**BEFORE THE PUBLIC UTILITIES COMMISSION OF
THE STATE OF CALIFORNIA**

**PREPARED TESTIMONY OF
DOUGLAS H. HAMILTON ON BEHALF OF
THE ALLIANCE FOR NUCLEAR RESPONSIBILITY**

A.2. My testimony for this proceeding relating to the Diablo Canyon Nuclear Power Plant (DCNPP) is to review and evaluate the results made public (to date) of the investigation into the seismic hazard posed to the DCNPP by the Diablo Cove fault zone, as the Commission did "expect" them to do per D. 12-09-008. I make no comment on PG&E's assessment of the Inferred Offshore fault and San Luis Ridge fault pending review of the so-called "Final Report" they expect to publish in July 2014. The Diablo Cove fault is of special interest in that it is a zone of north side up right reverse oblique faulting that displaces the Obispo Formation bedrock of the DCNPP Unit 1 Turbine-Generator and Reactor Containment foundations. The real possibility of renewed surface displacement along faults of this zone has the potential consequence of putting the safety of the plant, the electricity it provides to the state power grid, and potentially the health and property of the public at risk.

Figure 1

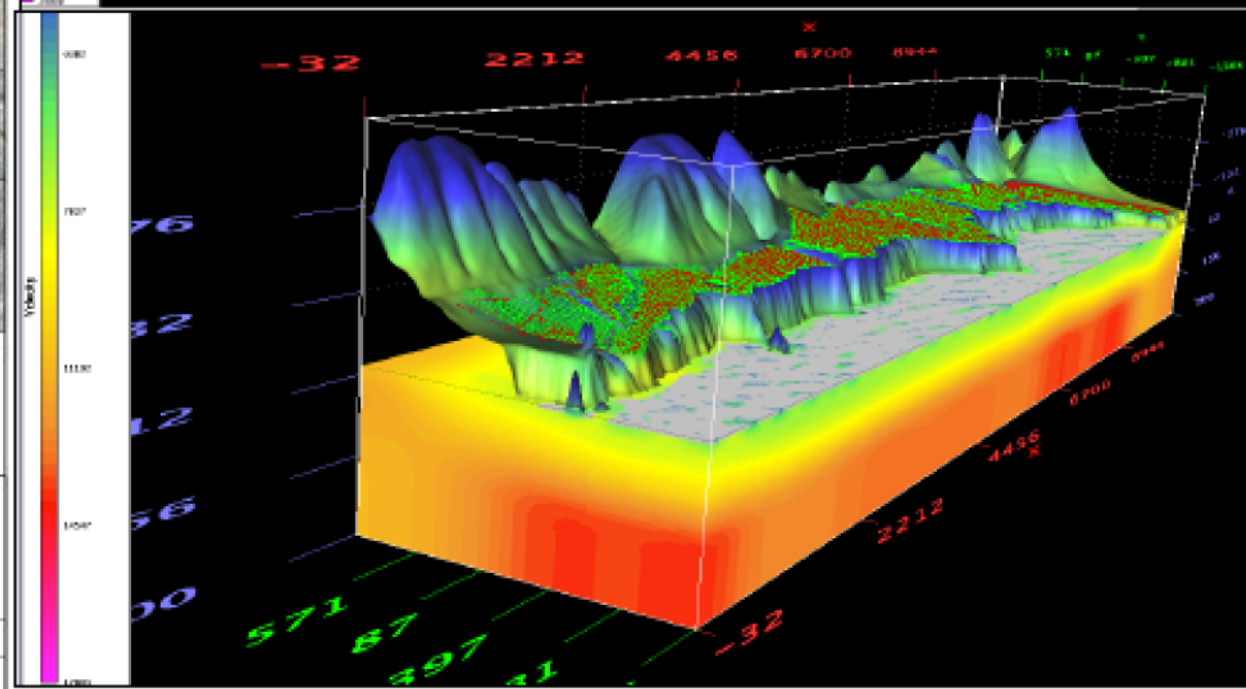
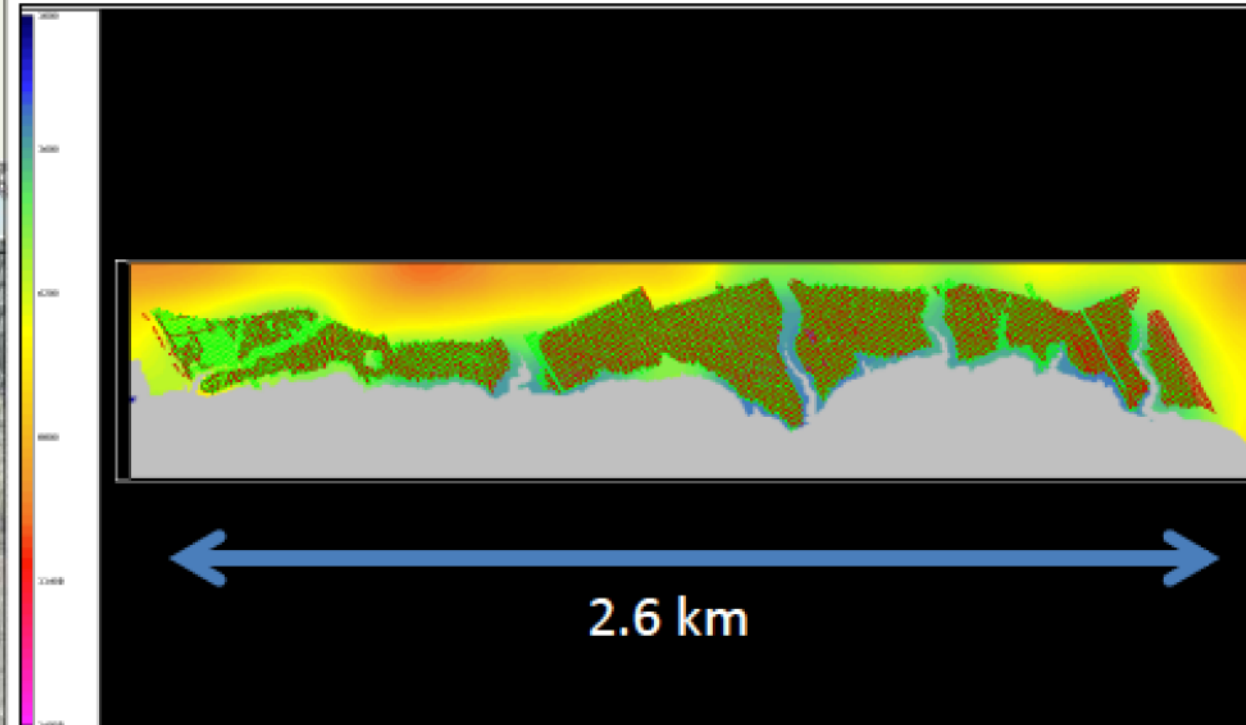
My analysis of certain figures within PLATE 3 (*Figure 1*) from PG&E's report notes that the map fails to identify the fault trace of the Diablo Cove fault or the more well known features of their own admission such as the Shoreline and other faults clearly discernable in the Islay shelf area along the shore of Estero Bay northeast of Pt. Buchon.

The marked boundaries (brown lines) of the survey area are indicative that the survey method chosen by PG&E is limited by the natural conditions in the area that do not allow the research vessel to get close enough to shore to properly image the off shore extent of the Diablo Cove Fault to the point of its likely intersection with the Shoreline fault. Imaging structures in the massive Obispo tuft breccia that forms the prominent seafloor outcrop in this area is likely not to be possible in this zone. Seismic energy input in connection with the survey will be reflected back from the rough high velocity surface showing only "hash" in the subsurface.

Figure D-026

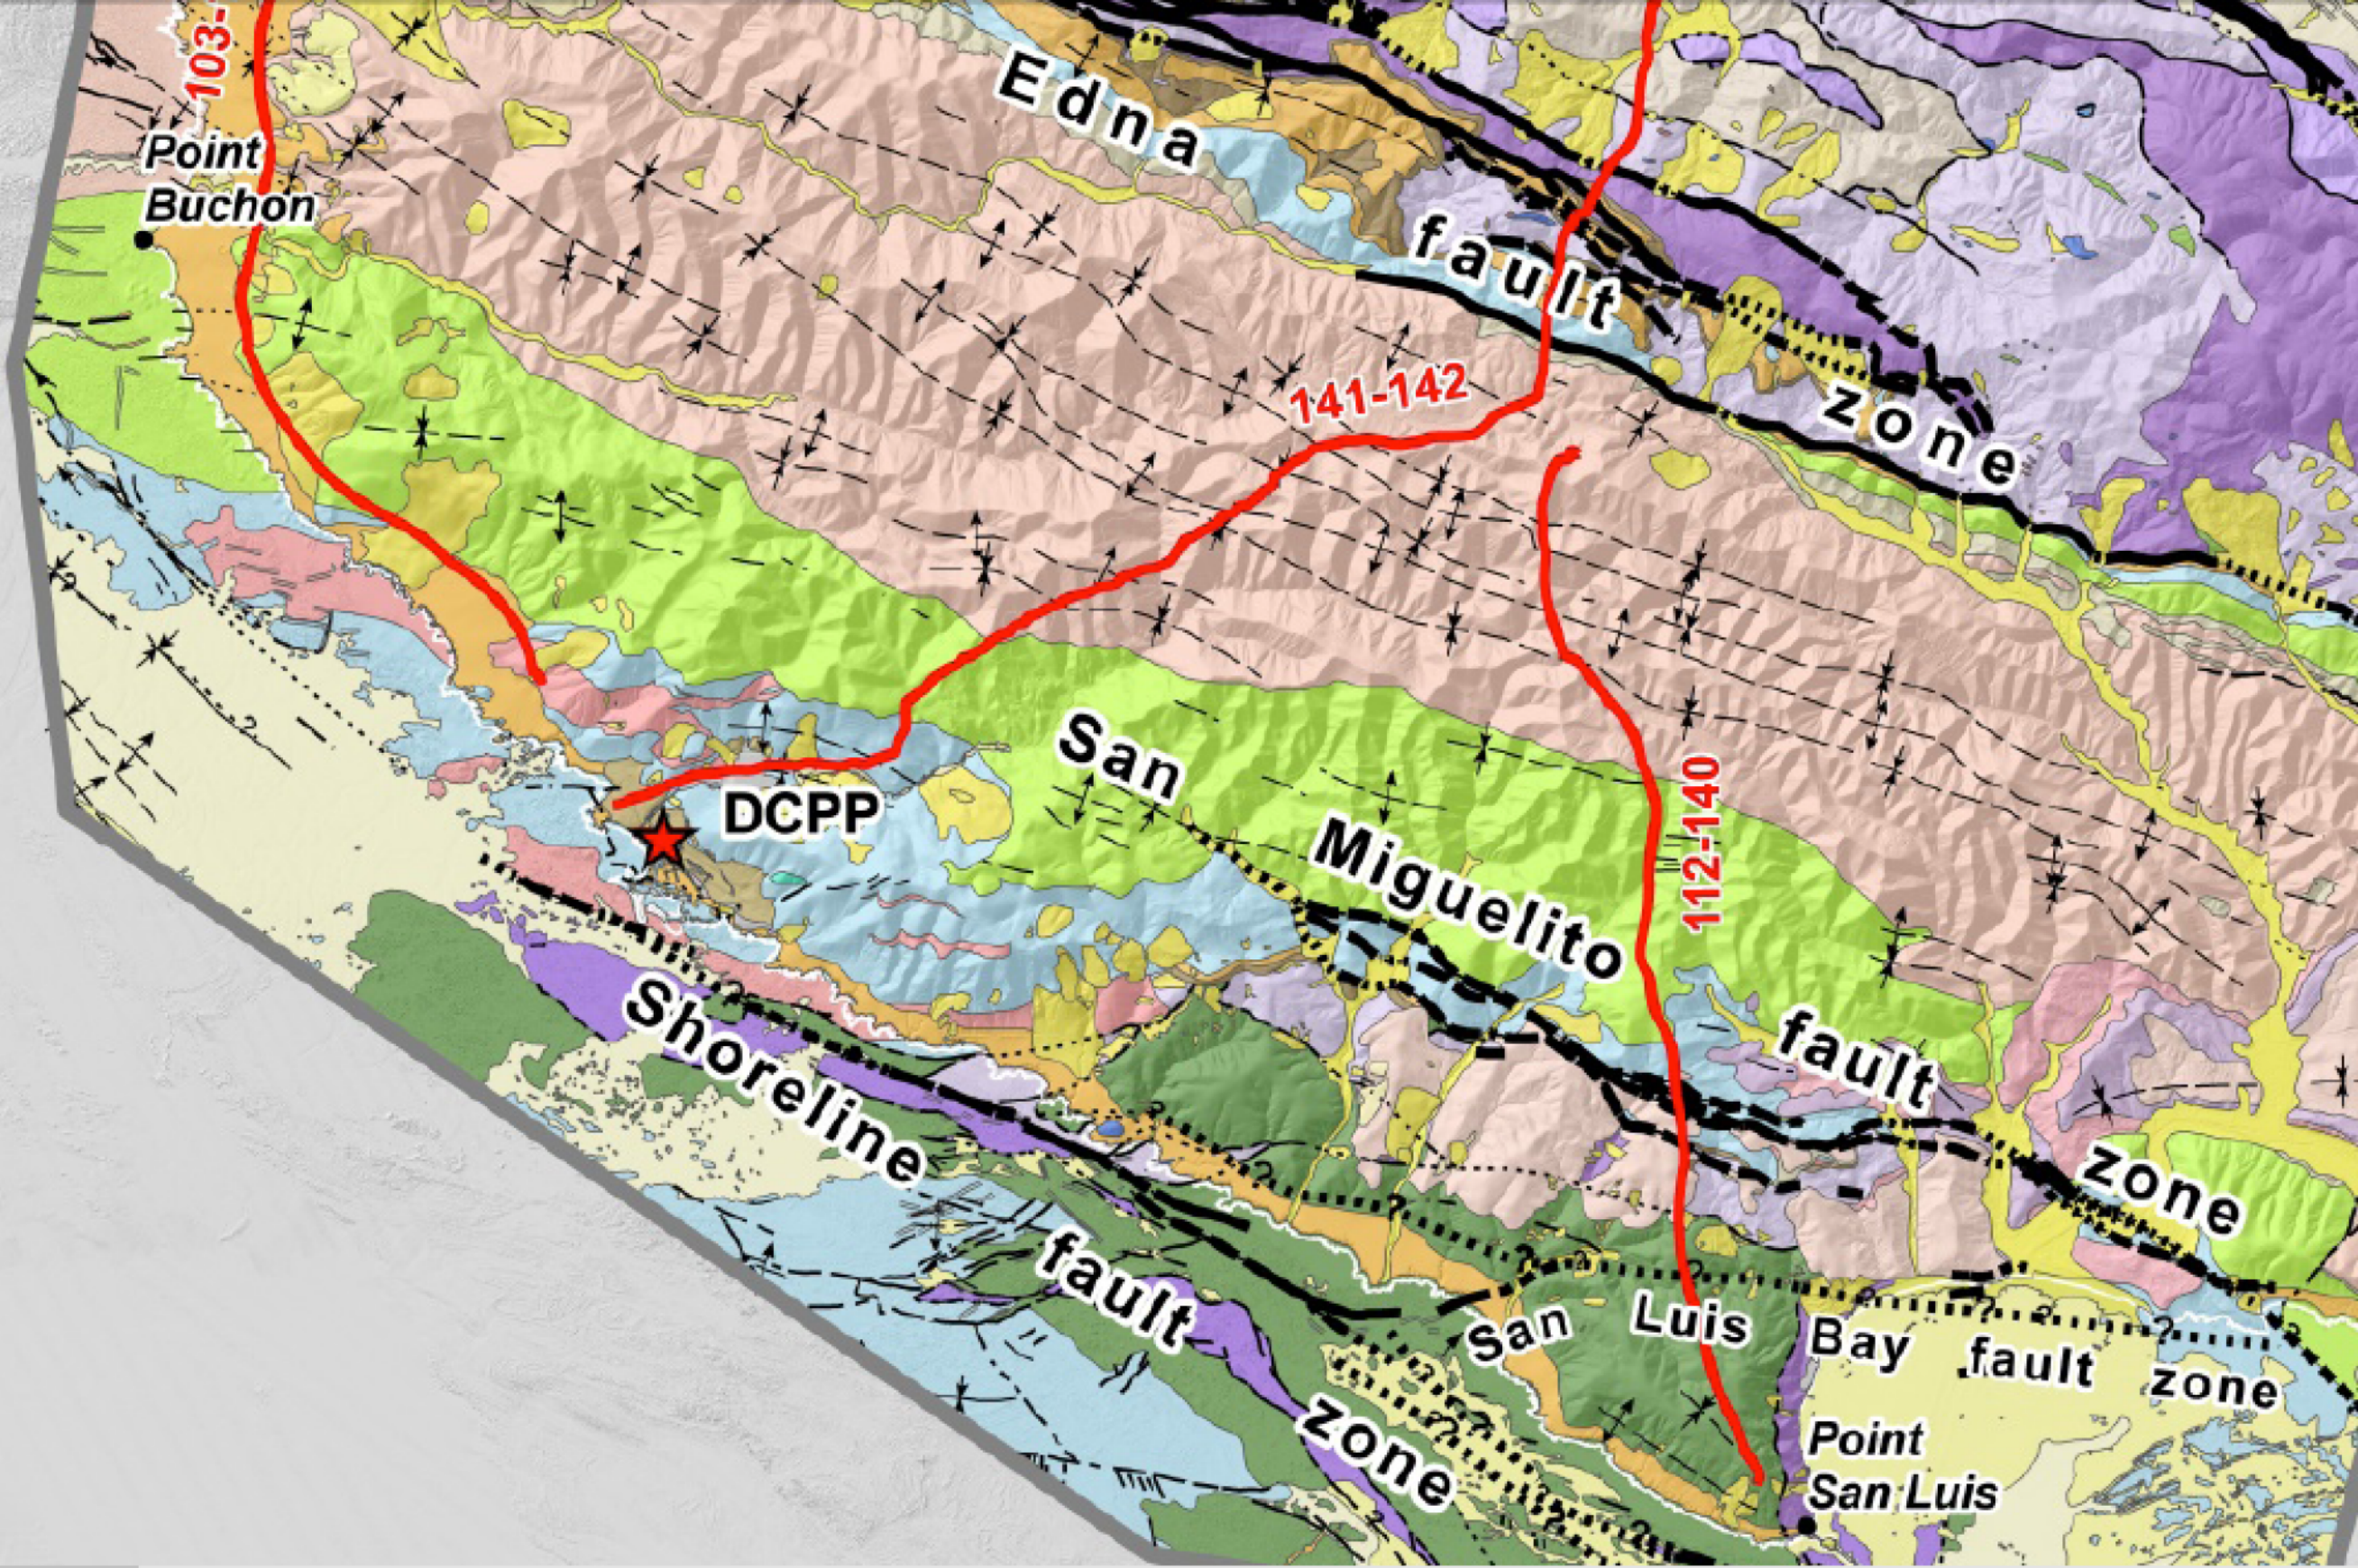
The track of vibroseis line 141-142 is shown in *Figure 5*.¹¹ The seismic reflection image of this line with interpretation by Dr. Unruh is shown in *Figure 6*.¹² The trackplot shows the south end of this line terminating on the Diablo Cove north headland about 200 feet short of the trace of the headland crossfault. Dips of bedding along both the Wastewater Holding Pond (WHP) and Diablo Cove seacliff exposures along this headland measured by Jahns in 1966, Hall (USGS) in 1972 and Hamilton in 1991 range between 30 and 70 degrees with highly disturbed Obispo Formation near the end of the vibroseis line. Unruh’s interpretation of the line instead shows nearly flat lying Obispo strata, which clearly does not match the observed geology. As to the nearby trace of the Diablo Cove fault, which is some 500-700 feet from but subparallel to line 141, no imaging of this steeply dipping structural discontinuity is evident in the vibroseis image and none would be possible given the character of the geology. Consequently, this line provides no information about the Diablo Cove fault.

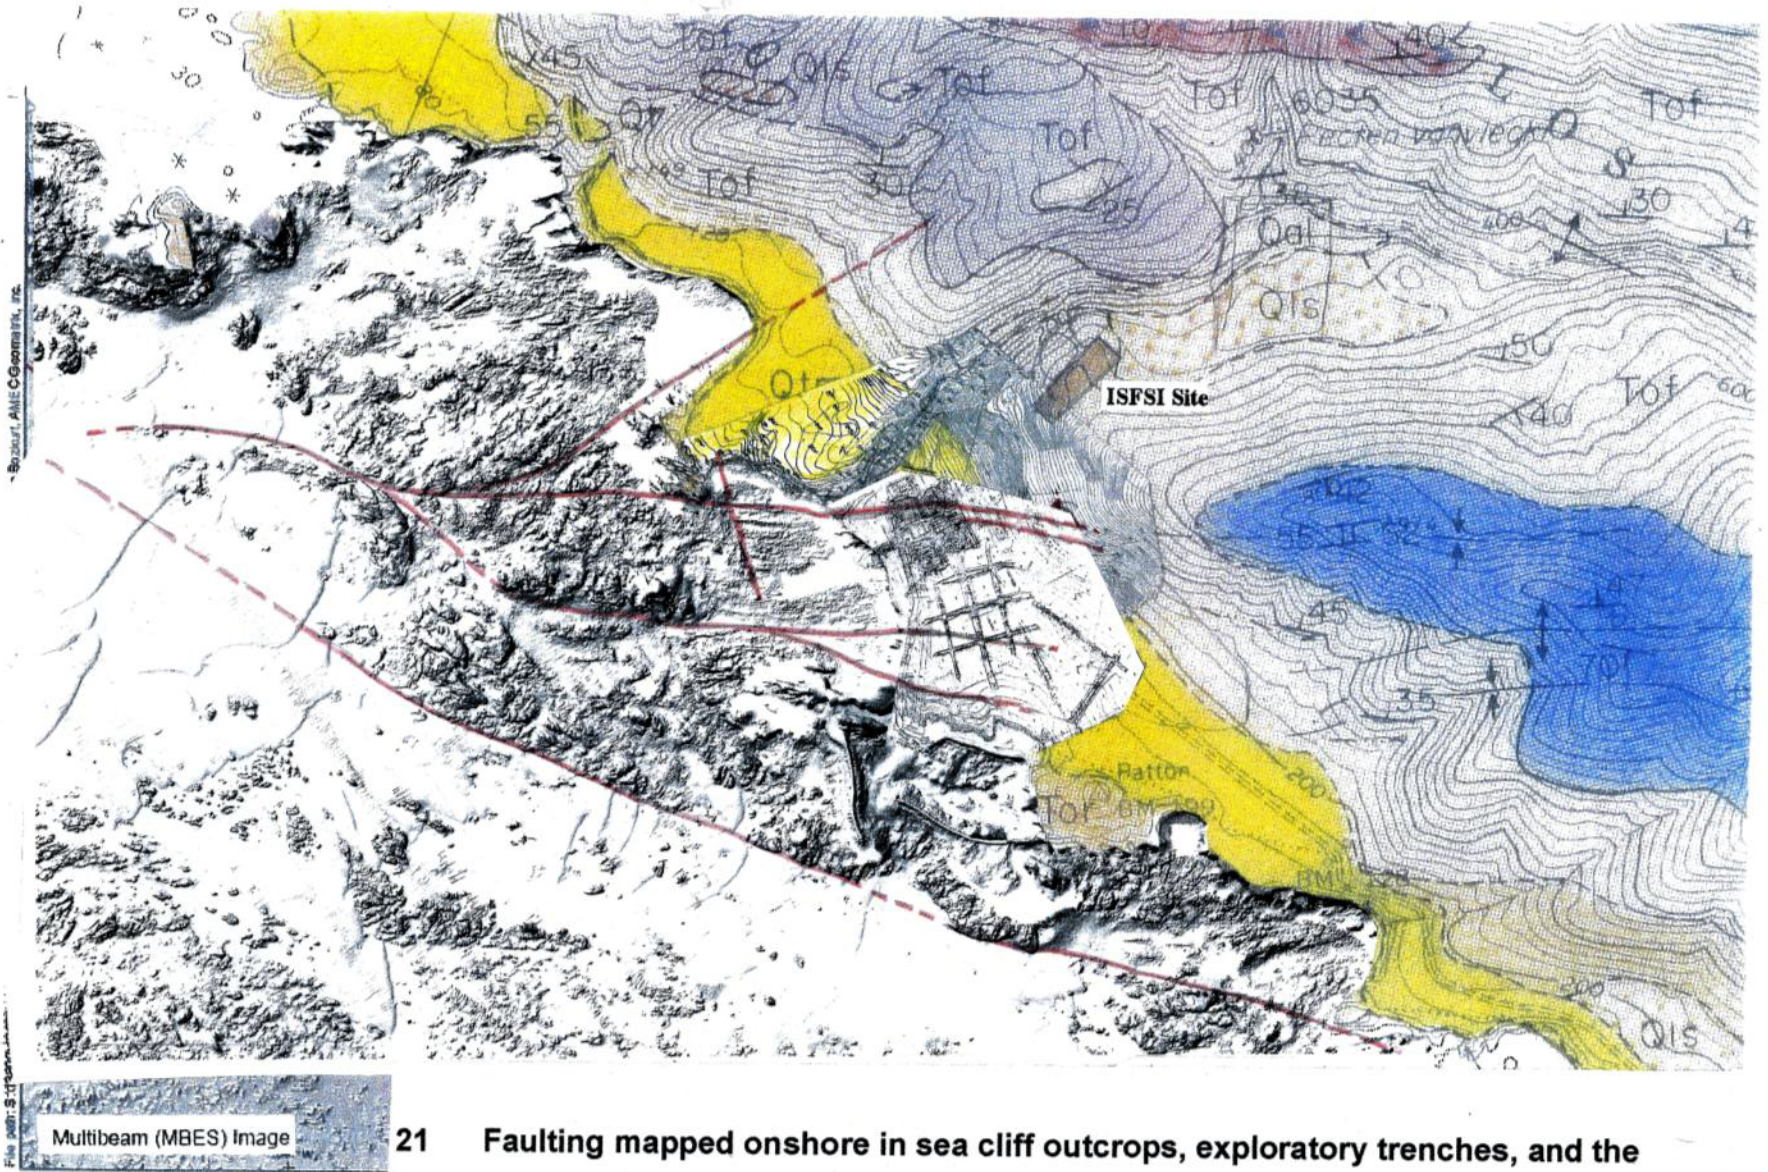
JOHN CASKEY: Yes, those east-west striking faults that you were talking about? It looks like that's that area...*(Figure 9)*²⁰

DOUG HAMILTON: This is the east-west to what I call the Diablo-Cove fault. The bedding, you can actually see the bedding out here.

DOUG HAMILTON: And the footwall side but the bedding over on the hanging wall side is more like this. It's at a very high angle to the bedding on this side. So although it looks like the displacement is rather small, Jahns thought it was larger by the time it got to the Shoreline fault, which is not that far away. And it seemingly is even bigger by the time it gets to where it looks to me like this cross-fault is displaced at the point of intersection.

**Marine terrace shoreline angles at DCPP
(data from Hanson et al., 1994)**

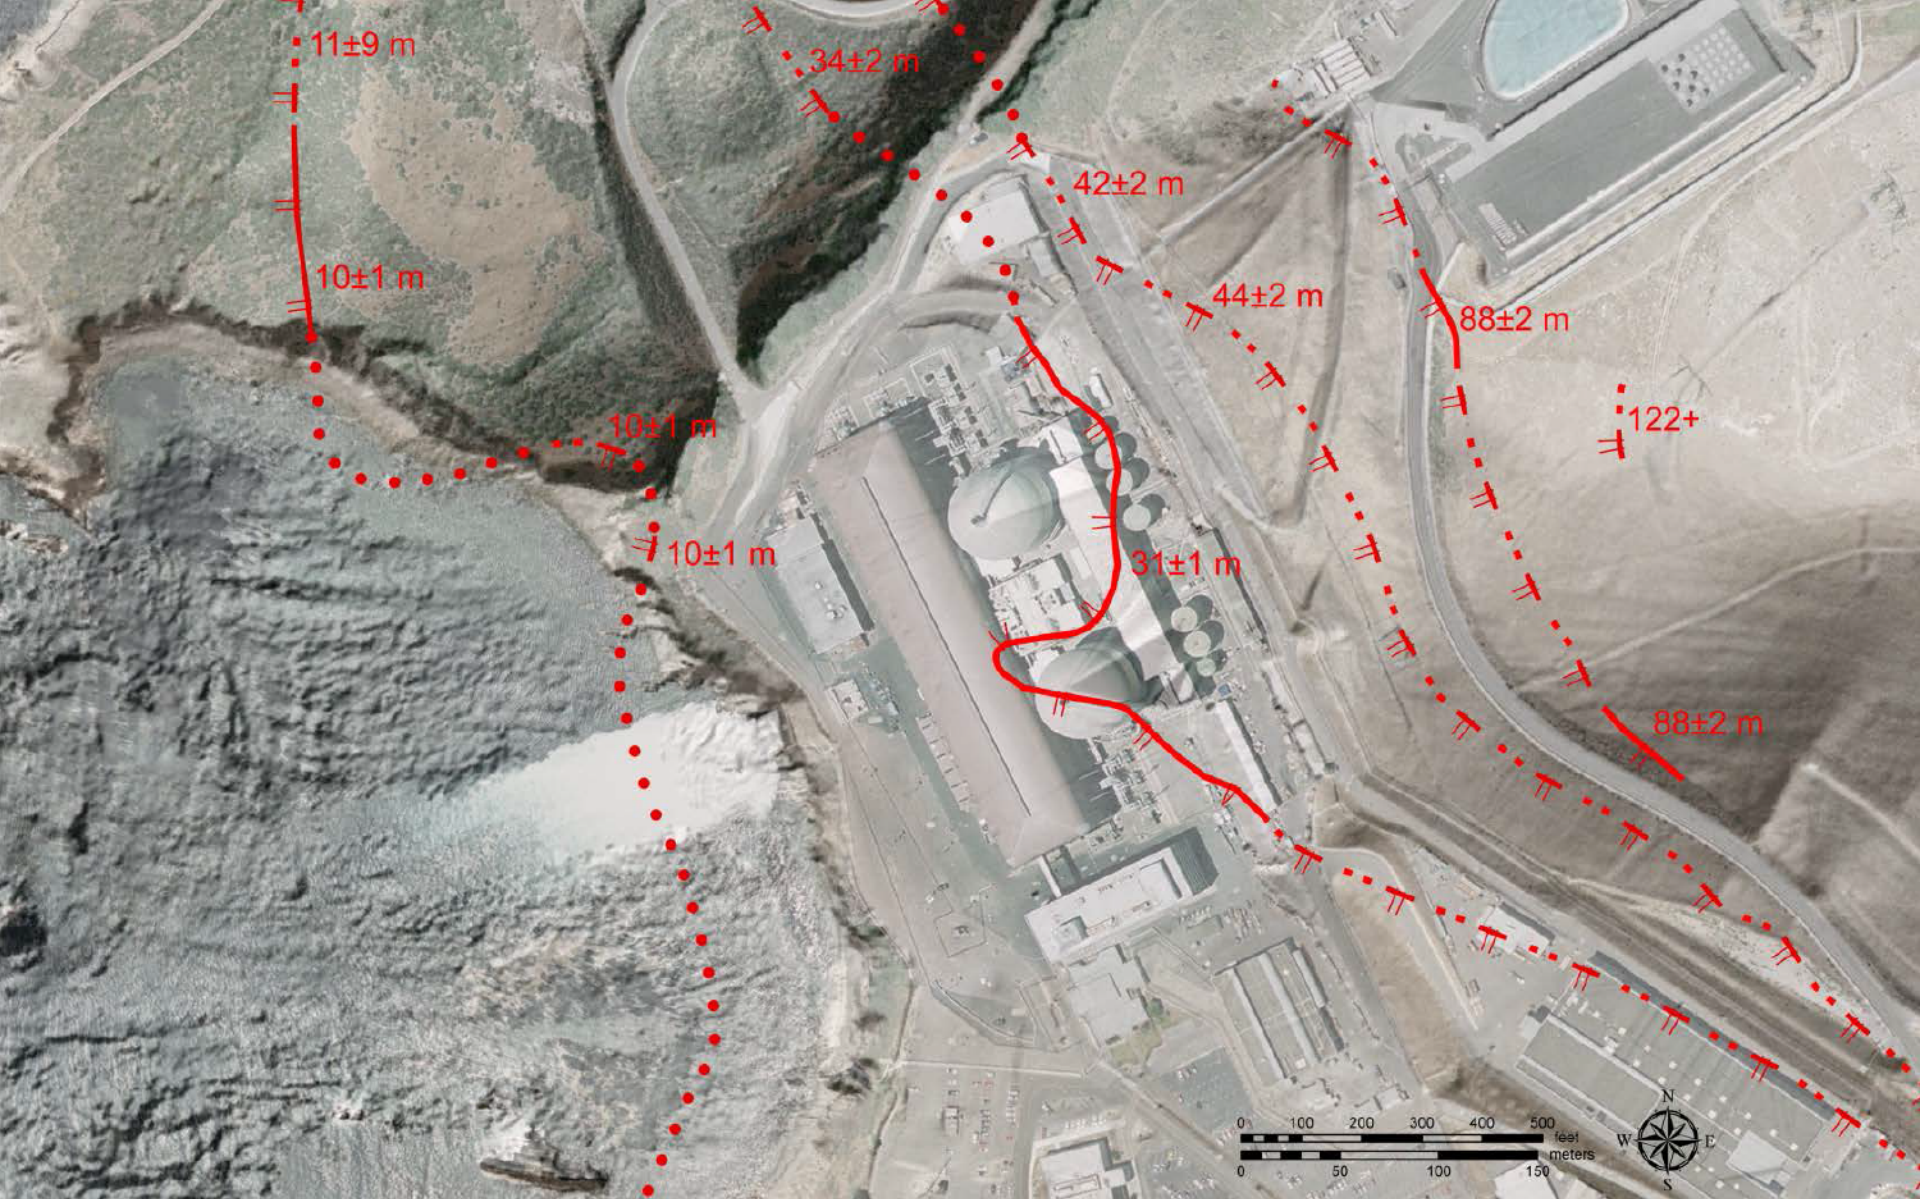
My analysis of “Slide 18” accompanying the above transcript of Lettis' description (**Figure 10**) reveals scant “hard evidence” upon which to base his conclusions.²⁷

- Lettis' Slide 18 only shows shoreline angles of the present and progressively older series of uplifted shoreline angles
- Only for the area labeled “Terrace 5E” directly in the plant area, is there any continuous documentation of the terrace shoreline angle (where it was mapped during Professor Jahns' original trenching program)
- The stages 7 and 9 are each defined by *only two points of observation* 100 or more meters apart in this area, and for those two points the indicated resolution of vertical continuity is identified as *plus or minus 2 meters*

Thus, faulting observed in the plant foundation where it does not exceed one meter of vertical displacement could pass unnoticed or undetected through the older shoreline angles upslope from the plant where resolution is plus or minus 2 meters.
